STAFF RECOMMENDATION

109 Evander Street

Application: New construction-addition

Description of Project: Applicant proposes to construct new side and rear dormers to the historic home.

Location & Form:

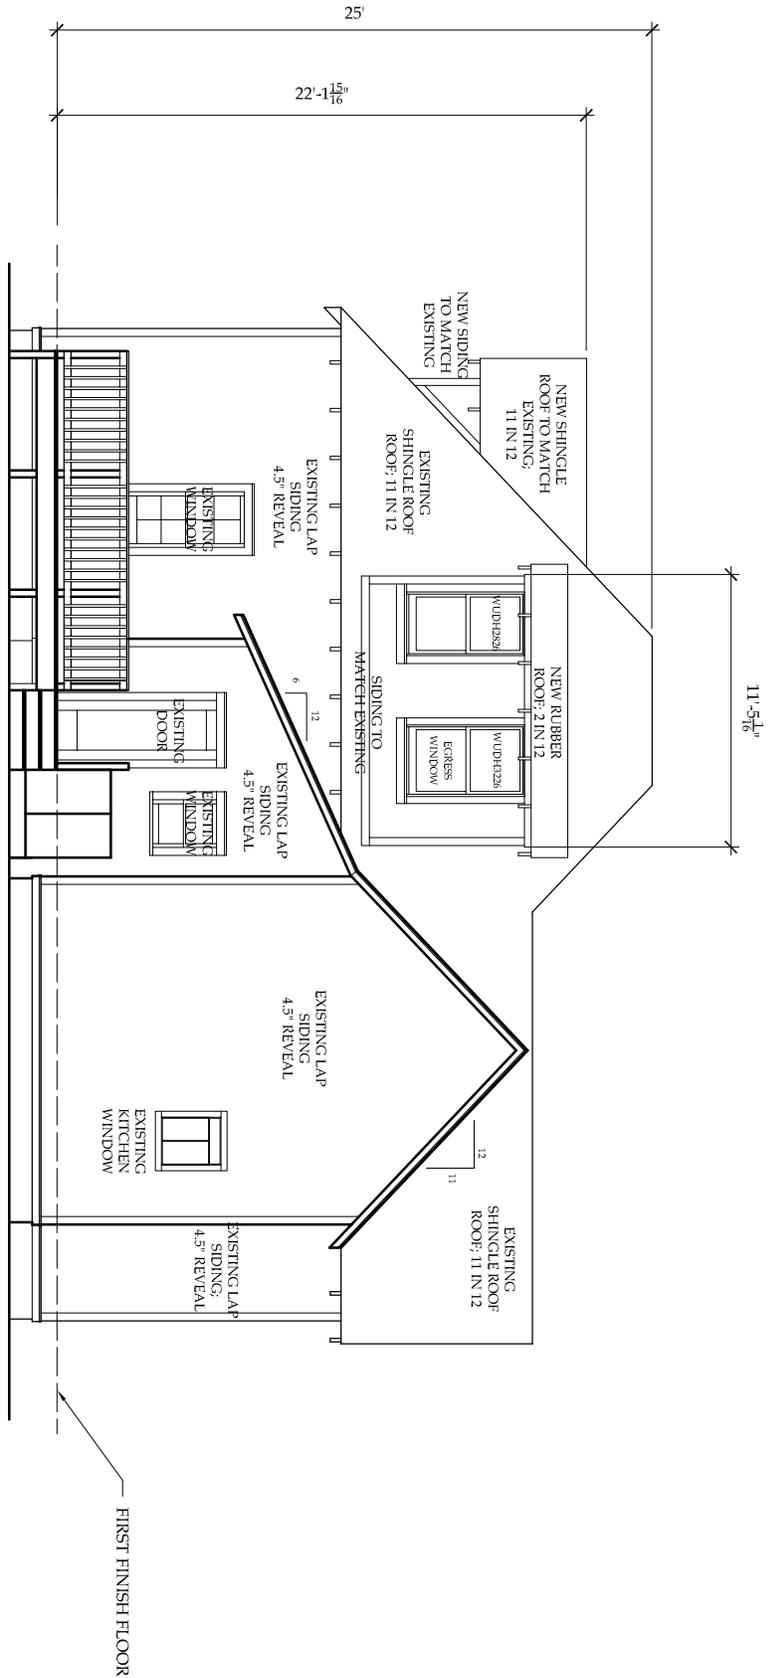
Side Dormer: One side dormer is proposed for the right side of the roof, the hipped form section, which will be minimally visible from public right of way because of the close proximity of the neighboring home. The dormer will be seven feet, nine one-fourth inches (7'-9 1/4") wide and seven feet, 5 inches (7' 5") tall. The dormer sits off the side wall and the ridge a minimum of two feet (2') each, as has been required in past projects. The dormer will have a gabled roof that will match the roof slope of the house.

Rear Dormer: The rear dormer will be minimally visible from the street. It will be eleven feet, five one/sixteenth inches wide (11'-5 1/16") and eleven feet (11') tall. The dormer will have a gabled roof that will match the roof slope of the house. The dormer is no taller than the existing house; however, the front wall of the dormer sits on the wall below. Since the rear dormer will not be visible from the public right of way, this is an appropriate location.

Both dormers could be removed at a future date without changing the historic form of the roof and because they are minimally visible they do not significantly change the appearance of the roof form. Staff finds that the dormers will meet Sections II.B.5 and 10 of the *Lockeland Springs-East End Neighborhood Conservation Zoning Overlay: Handbook and Design Guidelines*.

WEST ELEVATION
 $\frac{1}{8}'' = 1' - 0''$

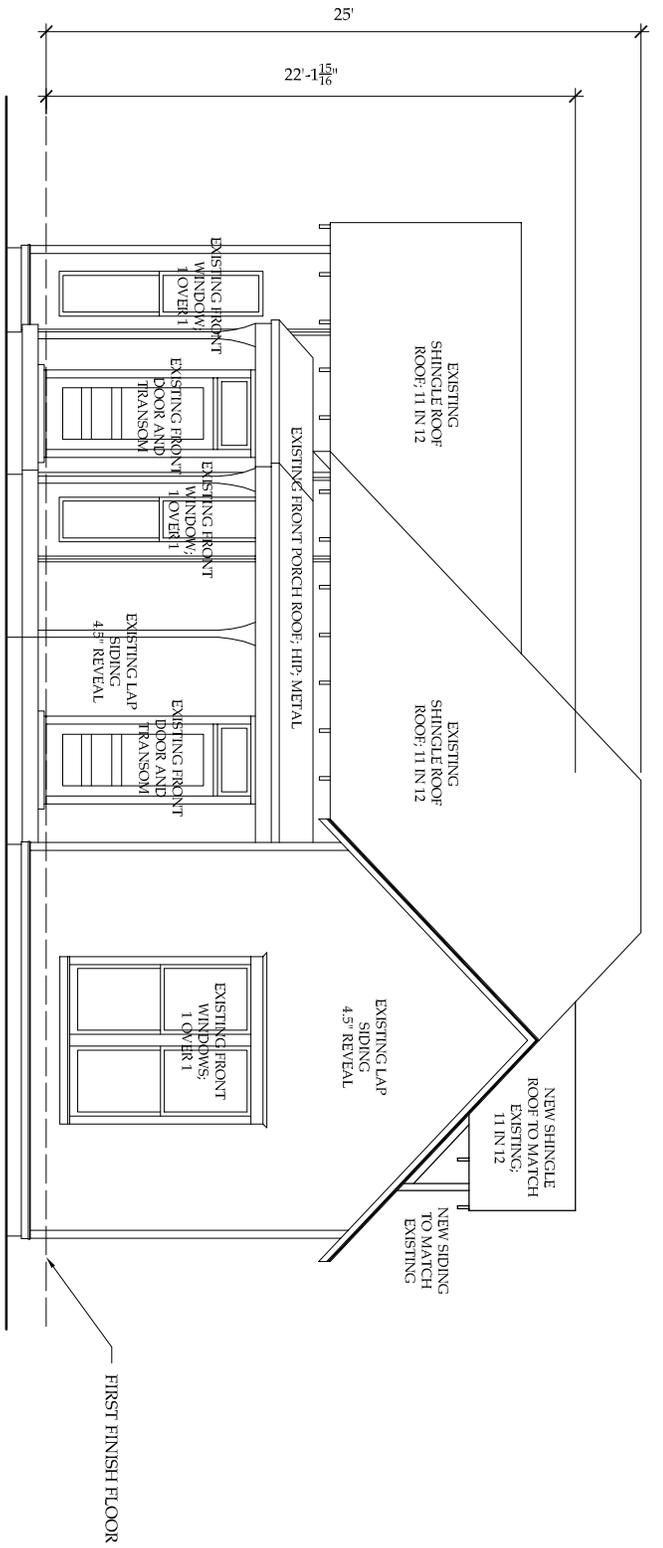
Materials: The materials include siding and trim to match the existing siding and trim and roofing to match the existing roofing in material and color. The window is not indicated; therefore, staff recommends the applicant receive staff approval for the window design.

Recommendation Summary: Staff recommends approval of the project with the conditions that the applicant receive staff approval of the window material and design prior to purchase and installation. With this condition, staff finds that the project meets II. B of the *Lockeland Springs-East End Neighborhood Conservation Zoning Overlay: Handbook and Design Guidelines*.
